Memorandum to the City of Markham Committee of Adjustment

File: A/205/22
Address: 37 Main Street, Unionville
Applicant: 2504373 Ontario Inc.
Agent: Memar Architects Inc.
Hearing Date: Wednesday January 18, 2023

The Applicant is requesting relief from the “Commercial One (C1)” and “Open Space One (O1)” zones under By-law 304-87, as amended, as it relates to a proposed two-storey commercial plaza. The variances requested are to permit:

DRAWING TITLE:
 SITE PLAN

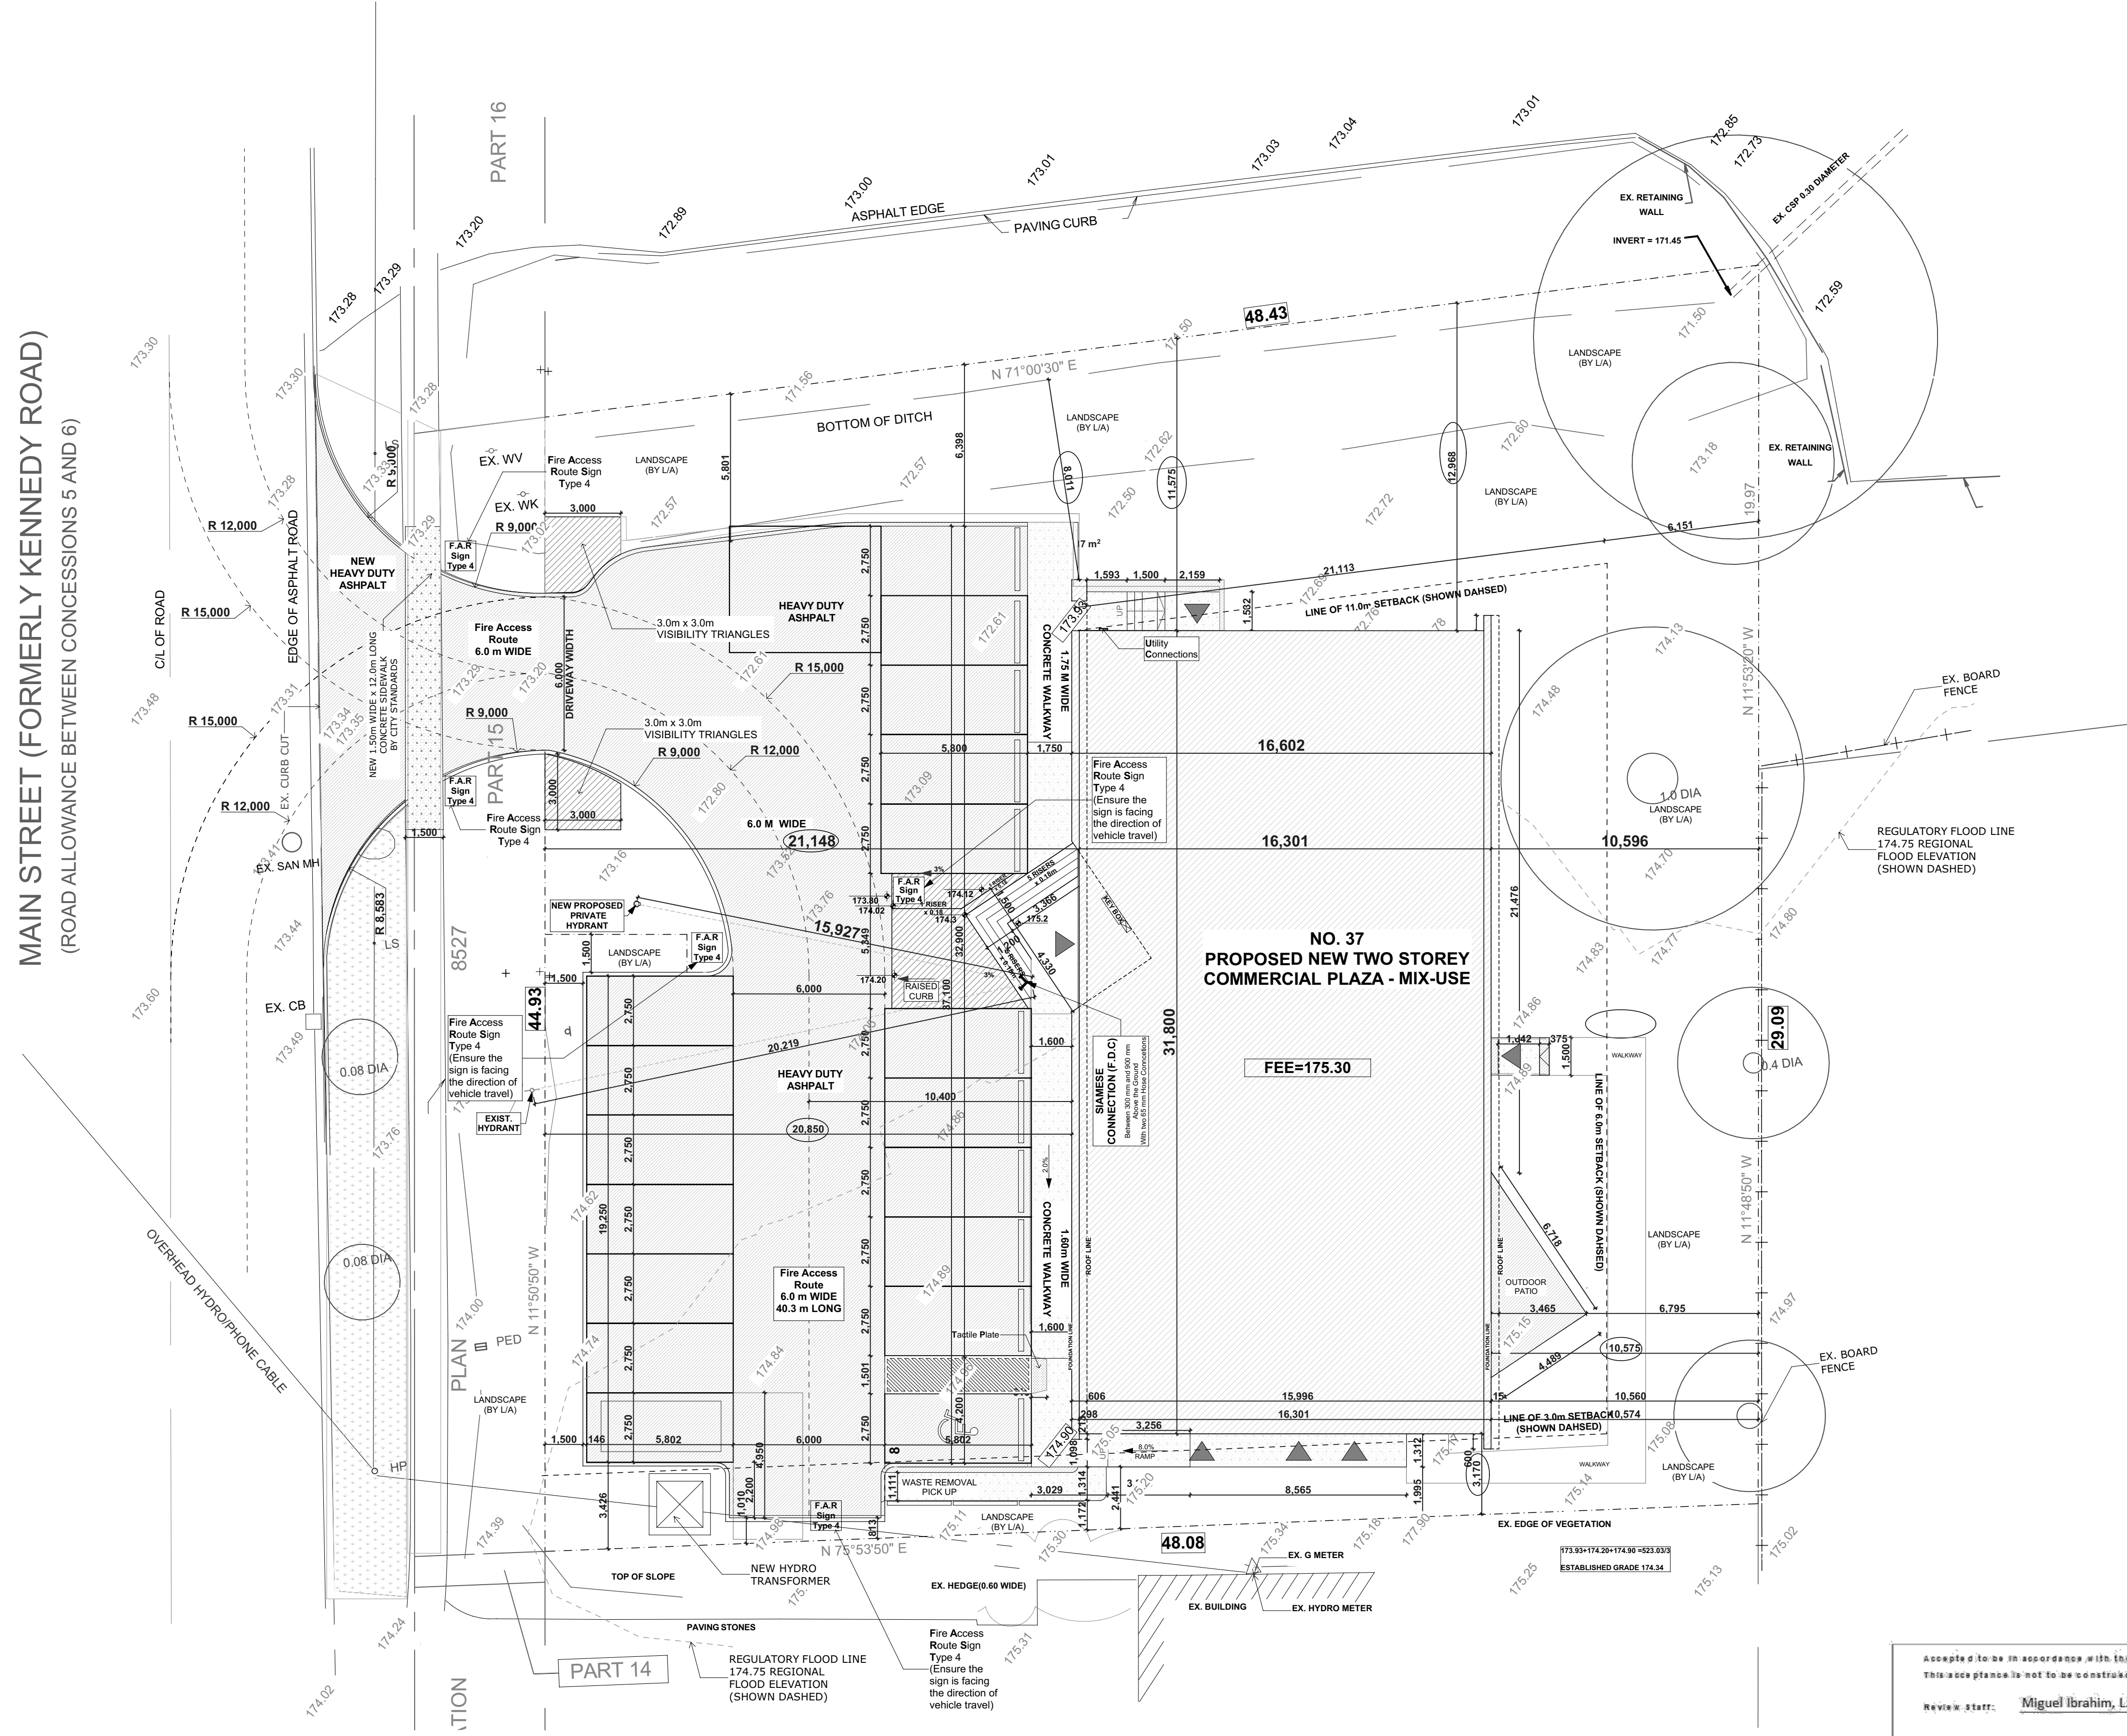
The Applicant is requesting relief to permit a minimum north side yard setback of 8.01 m (26.28 ft), whereas the By-law requires a minimum north side yard setback of 11.0 m (36.09 ft). This represents a reduction of approximately 27.18% or 2.99 m (9.81 ft).

The variance is entirely attributable to the proposed exterior stairs located on the north side of the building. Staff note that the alignment of the main wall of the proposed building provides an irregular north side yard setback which range between 11.0 m (36.09 ft) and 12.97 m (42.55 ft) to the main building wall. The setback from the property line to the main building wall meets the By-law requirements, however the exterior staircase encroaches into the required setback.

Staff are of the opinion that the proposed stairs and associated setback variance is minor in nature and will have minimal impacts to the adjacent property.

4. (Previous Comment 6)	Please provide the updated regulatory floodline on the Site Plan drawing.	Partially Addressed. It was noted that the updated regulatory floodline has been illustrated on the proposed grading plan, however, it has not been included on the site plan and topographical survey. Please ensure at the subsequent application stage the site plan and topographical survey include the updated regulatory floodline.
